Attachment A – Detailed Response to Submissions Table

Attachment A – The Sutherland Hospital Operating Theatre Upgrade (SSD-11099584) – Detailed Response to Submissions Table

Figure 5 Excerpt from the Landscape report showing the entrances into the new building and the main hospital building, marked as arrows.

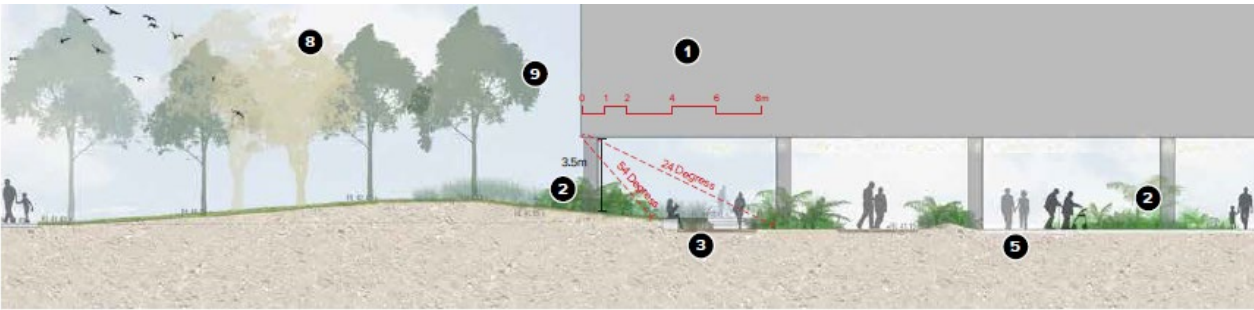
<p>7 Architectural and Landscape Plans</p> <p><i>Updated architectural / landscape plans are to be submitted providing:</i></p> <ul style="list-style-type: none"> a) <i>Further clarity on the entrance to the hospital, in particular clarifying the main entrance and if the new entrance is for patients or the public</i> b) <i>Provide a section view of the undercroft space including plans that illustrate the solar access to this space.</i> 	<p><u>Building entrances</u></p> <p>The main entrance to the hospital is not affected by the proposed development. The entrances into the proposed operating theatre building are intended for use by staff only. There are three points of access into the new building; two to the west end of the building near the carpark and one entrance into the MRI. All three entrances are intended for use by staff only and will have card / swipe card access. The new building is not intended for use by visitors. Figure 6 below provides a pedestrian scale perspective of the new building as viewed from the existing car park, looking towards the entrance of the new building.</p> <p>This perspective demonstrates that the entrance does not read as a main hospital entrance.</p>
